re: Retaining Wall Certification
Proposed Residential Development - Morgan's Creek Stage 1
762 March Road - Ottawa

file: PG2234-MEMO.09

MINTO COMMUNITIES INC.
RETAINING WALL DESIGN - PROPOSED RESIDENTIAL DEVELOPMENT
762 MARCH ROAD
OTTAWA, ONTARIO

Report No.: PG2234
Drawing No.: PG2234-6
Revision No.: 2

GRADING PLAN

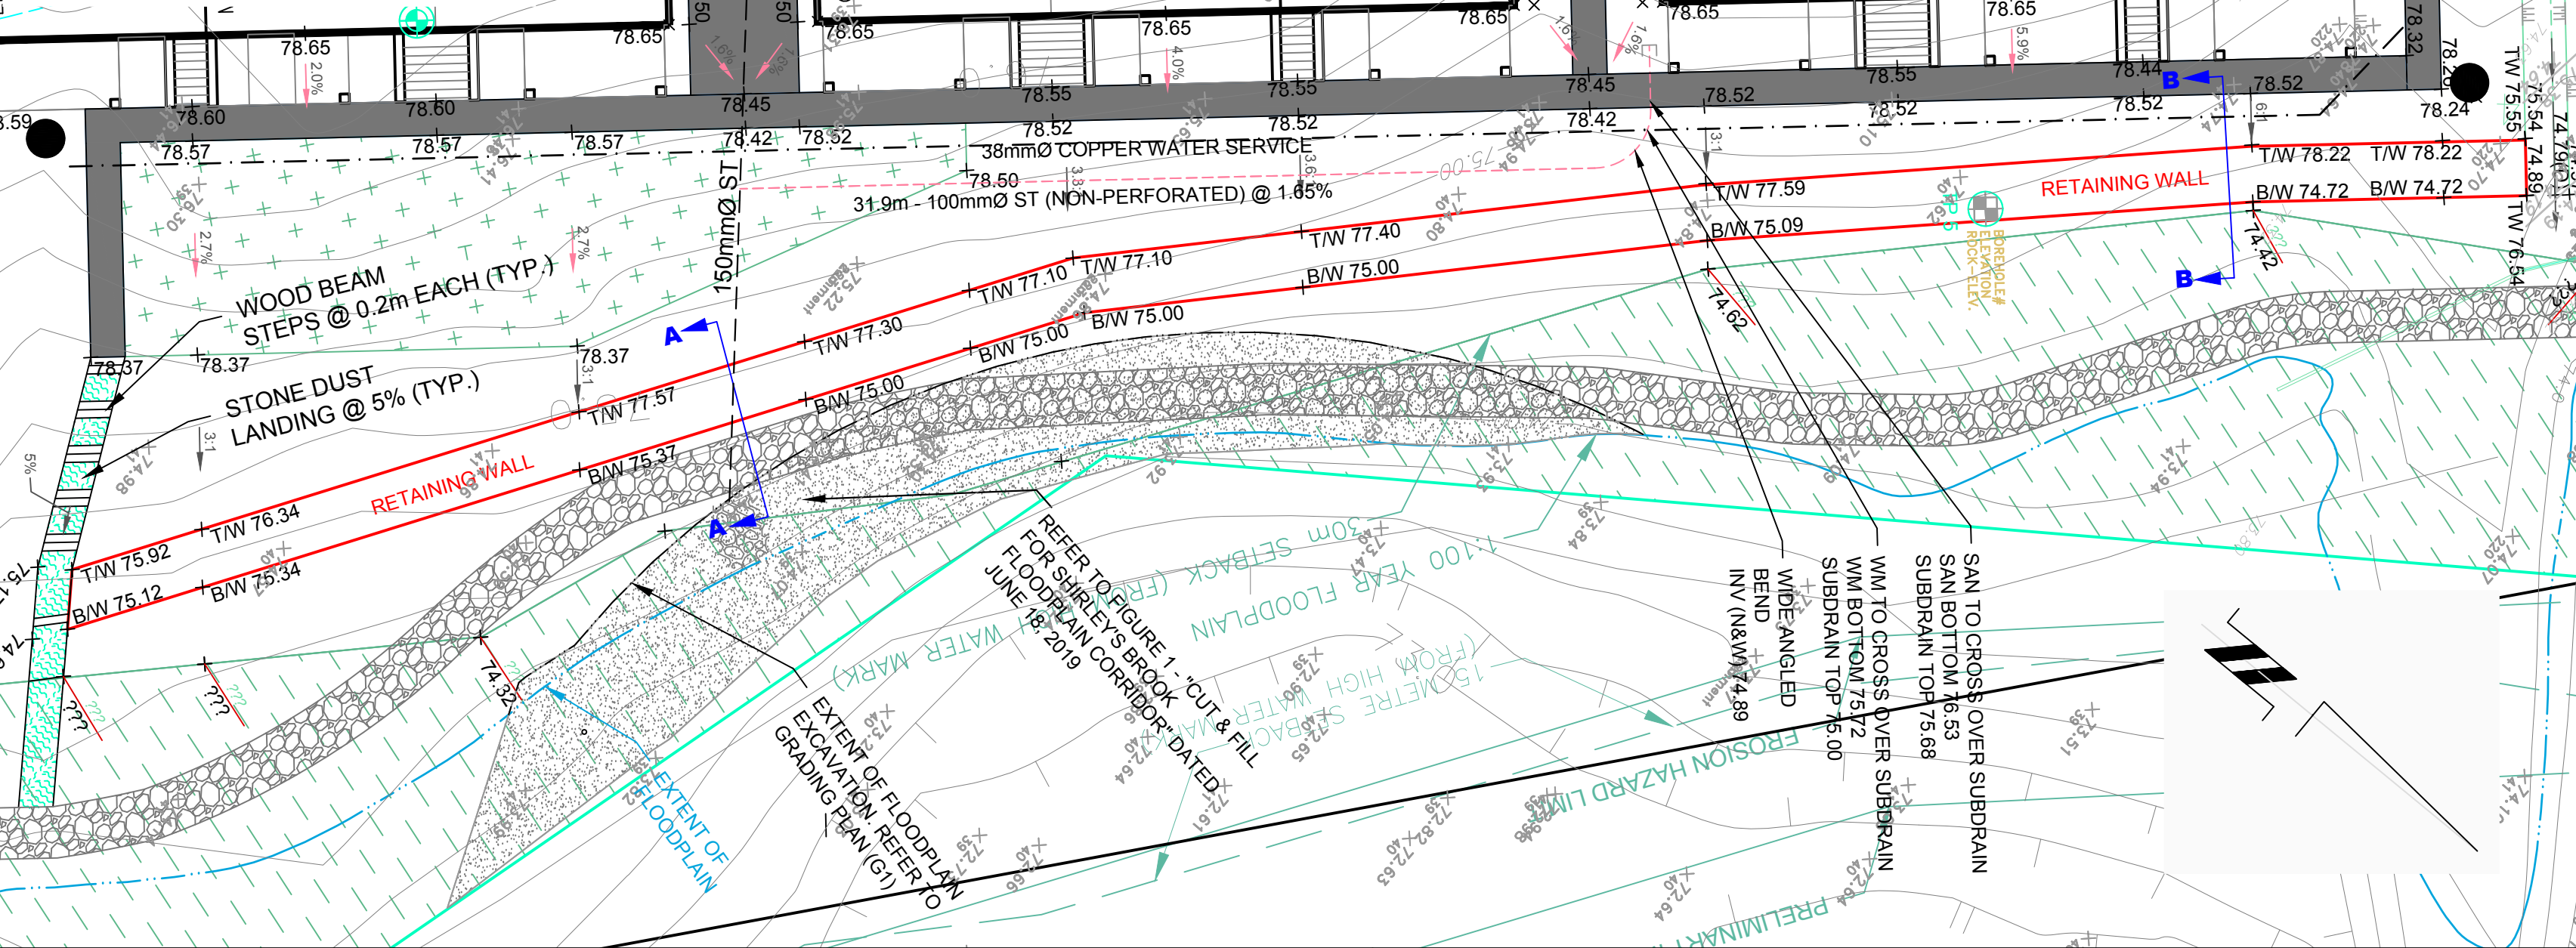
Comment: *We acknowledge the applicant's June 12, 2019 response, however, continue to recommend that the retaining wall design be updated to include the adjusted floodplain and certification from the responsible engineer that the wall will not be adversely affected by flooding or erosion associated with Shirley's Brook. This will be a required of our permit approval.*

Our revised retaining wall drawing, the attached Paterson Group Drawing PG2234-6 Revision 2, has been updated to include the adjusted floodplain.

Further, we certify that the proposed retaining wall will not be adversely affected by flooding or erosion associated with Shirley's Brook.
